**Arlington High School Building Committee
Finance Subcommittee Meeting
Thursday, August 10, 2023
Conducted by Remote Participation
4:00 PM – 4:30 PM
Agenda**

8/10/2023 AHSBC Finance Subcommittee Meeting
Meeting Materials

Change Order (CO)

**Planting & Light Pole Location at East Entrance Retaining Walls
Revisions to Drawing L-3.1**

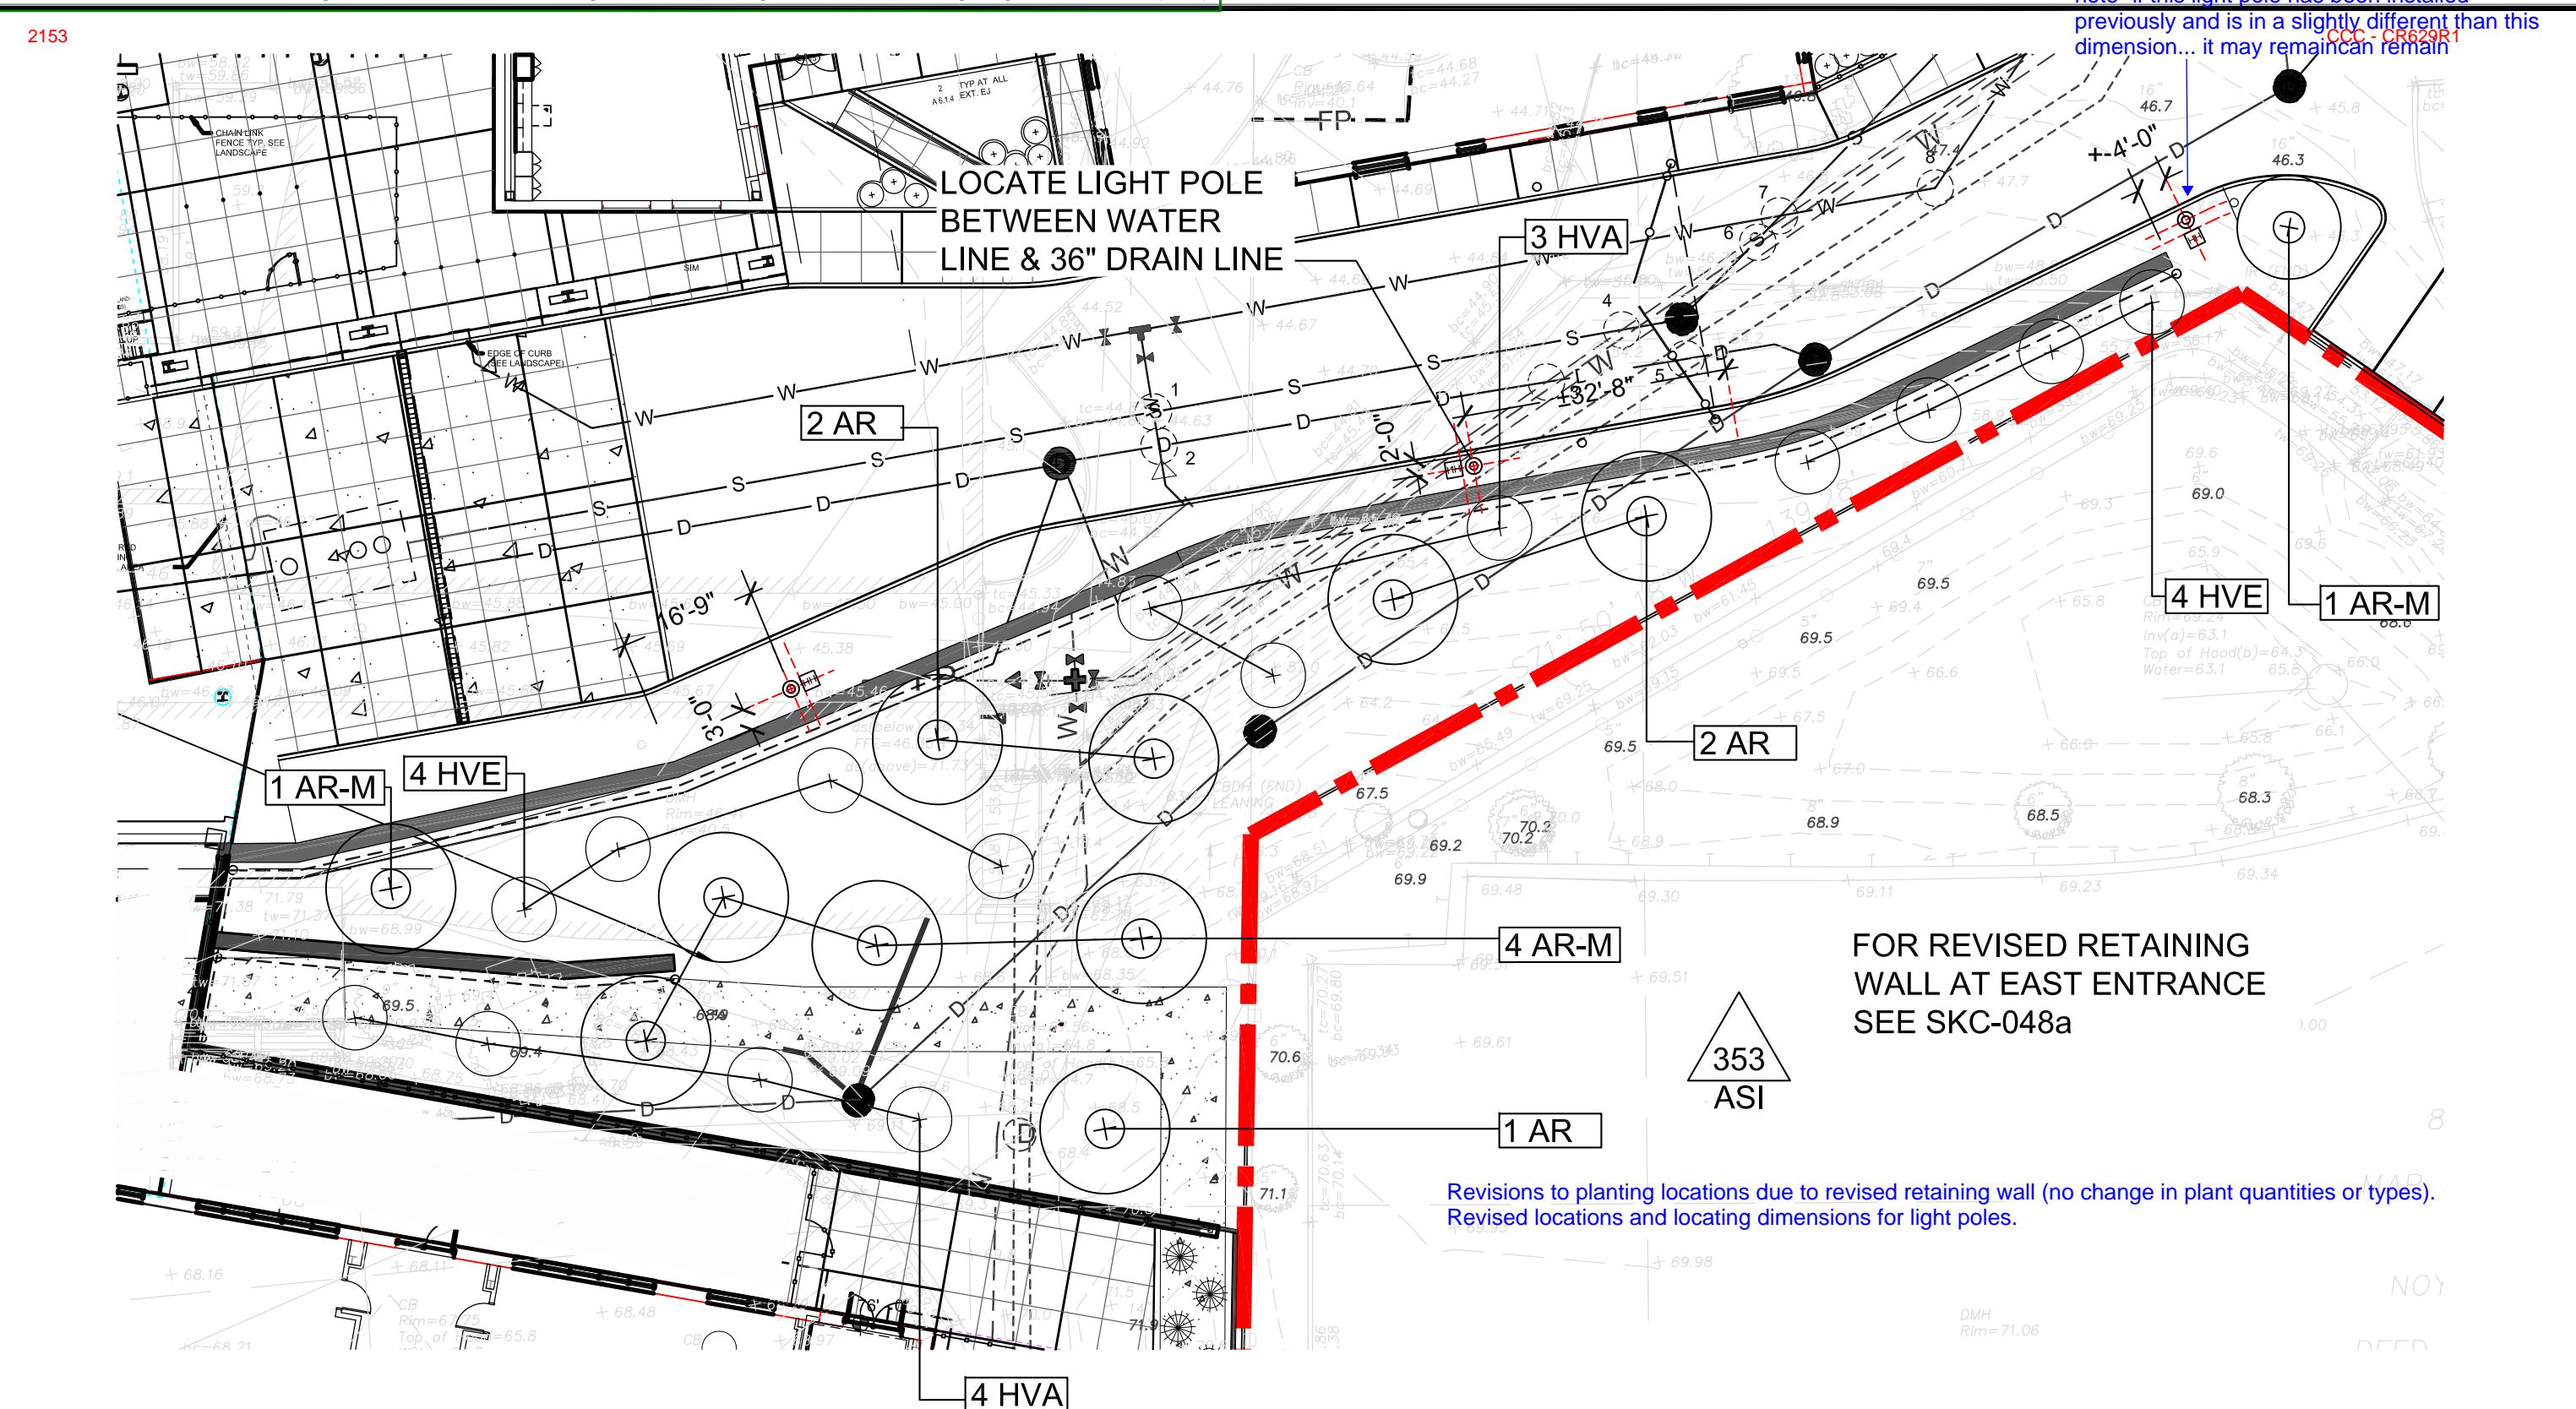
note- if this light pole has been installed previously and is in a slightly different than this dimension... it may remain can remain
CCC - CR629R1

RFI #78: P-9 sink Rm. P2.12

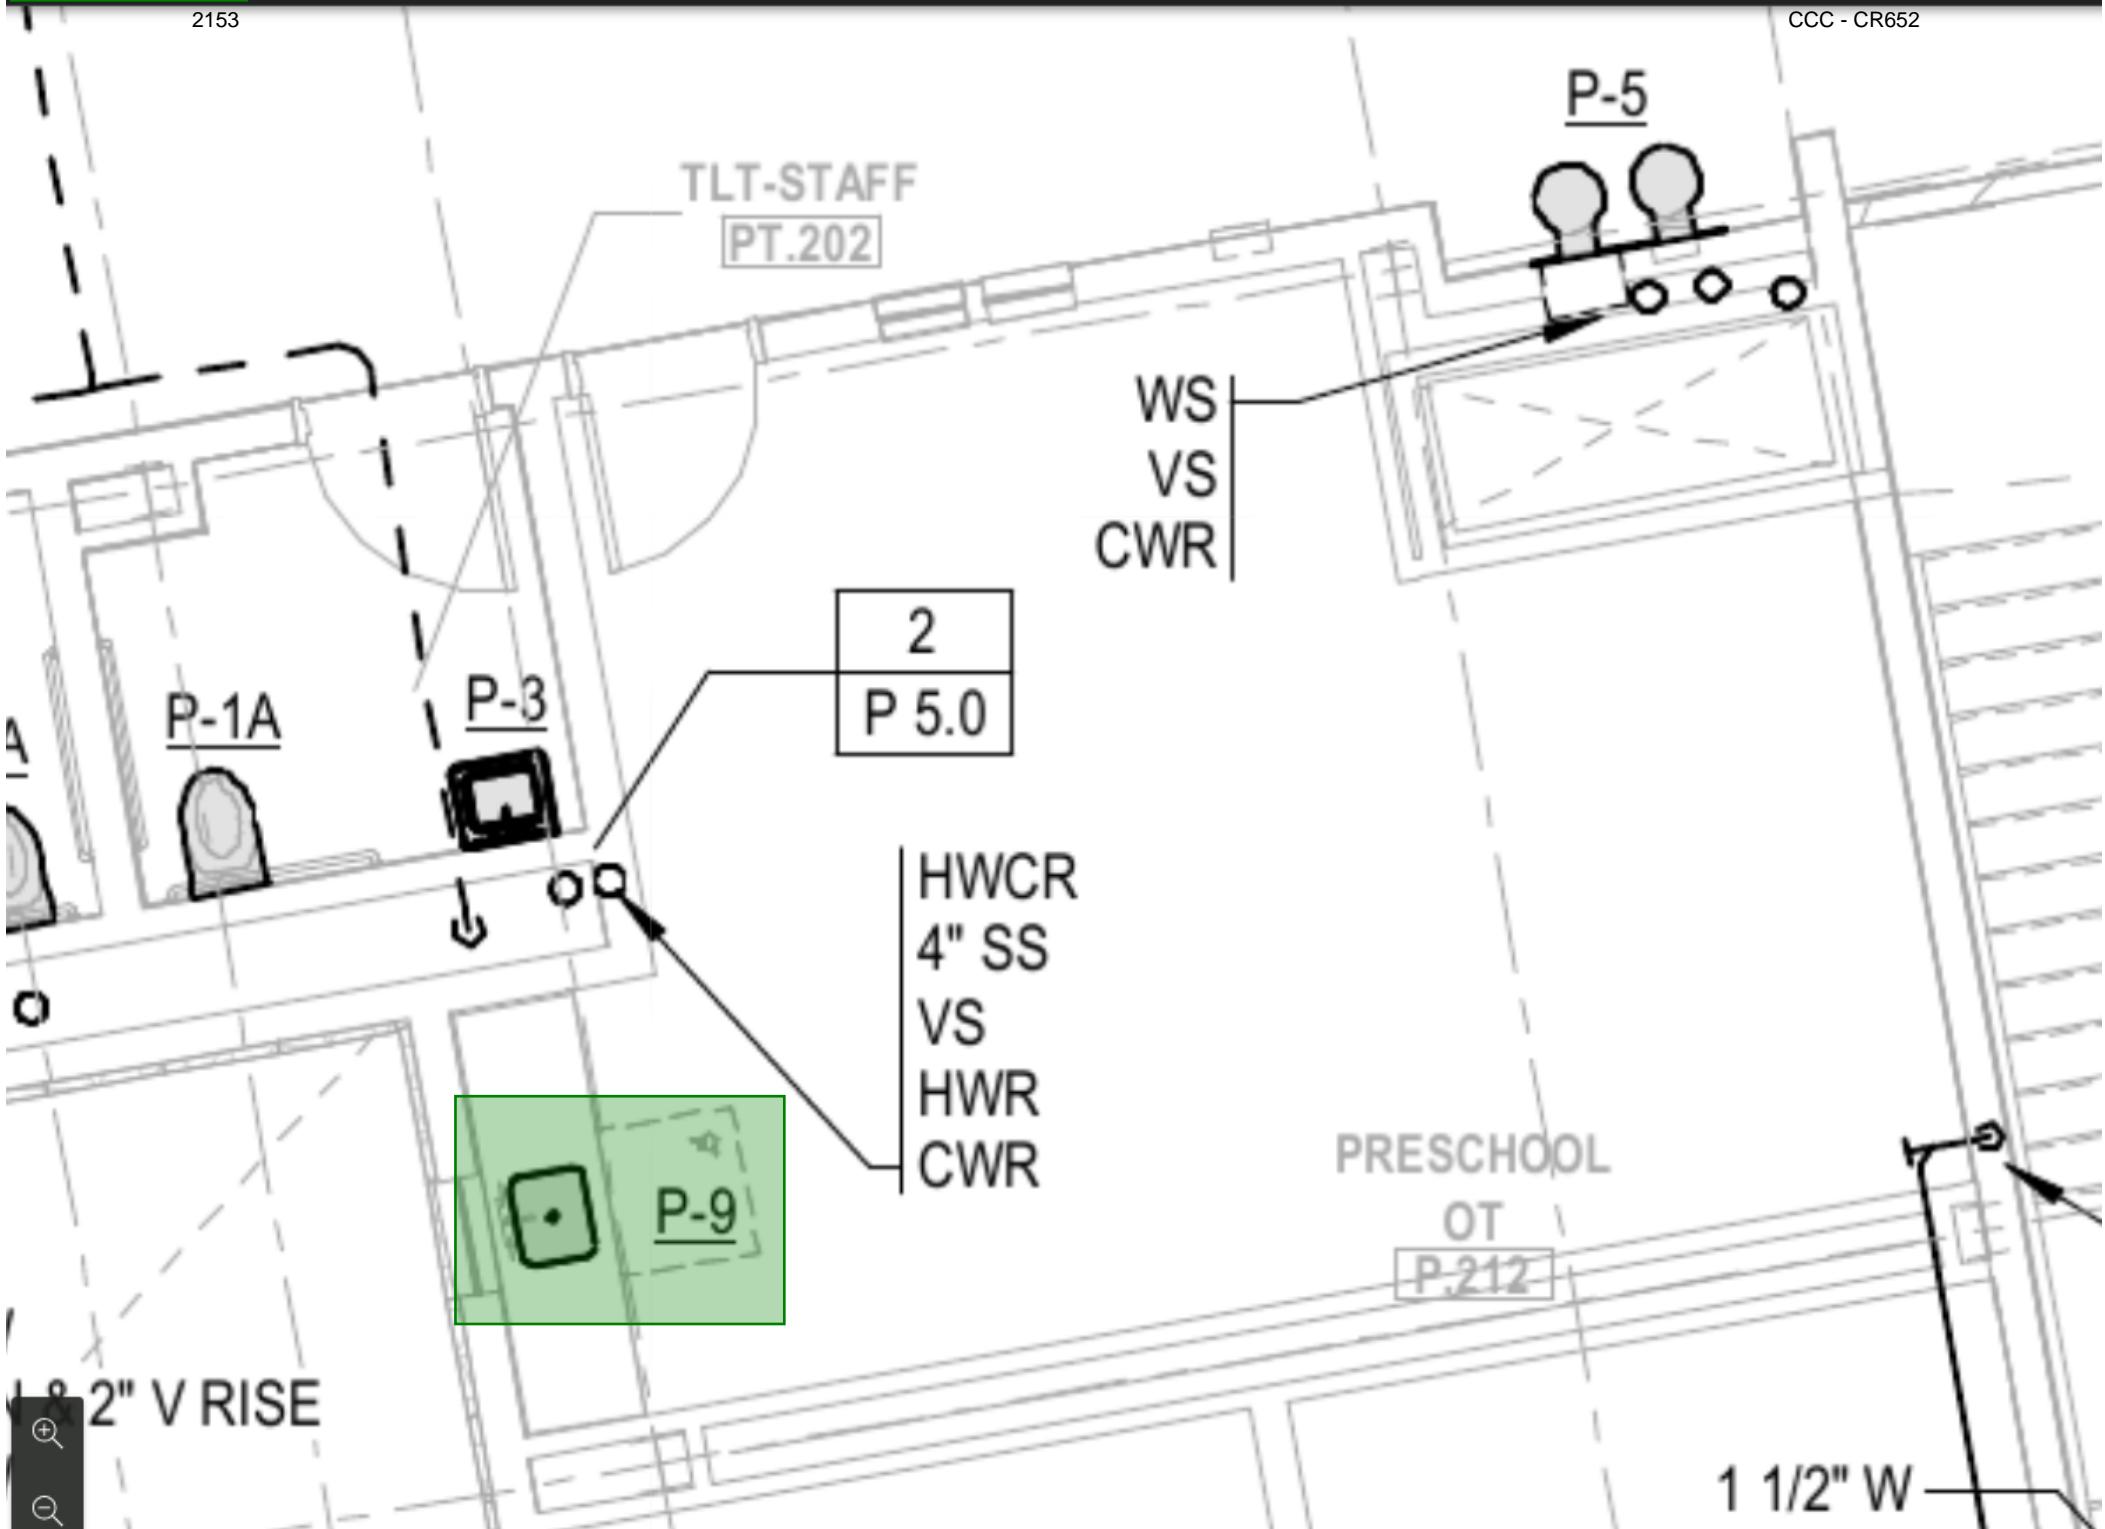
Plumbing Drawing P2.0C shows a P-9 fixture in Preschool OT P.212 of Building C Upper Level 1. After reviewing the drawing it appears there are no plumbing connections (waste, vent, and water) for the fixture.
Please provide an updated Plumbing Drawing for the intended design.

Question	Question from John O'Donnell E. Amanti & Sons, Inc. on Thursday, Jul 13, 2023 at 06:26 AM EDT There is a P-9 sink on C1.5 in Room P212 with no plumbing shown on the drawings. Please advise where the waste, vent and water piping should be installed.
-----------------	--
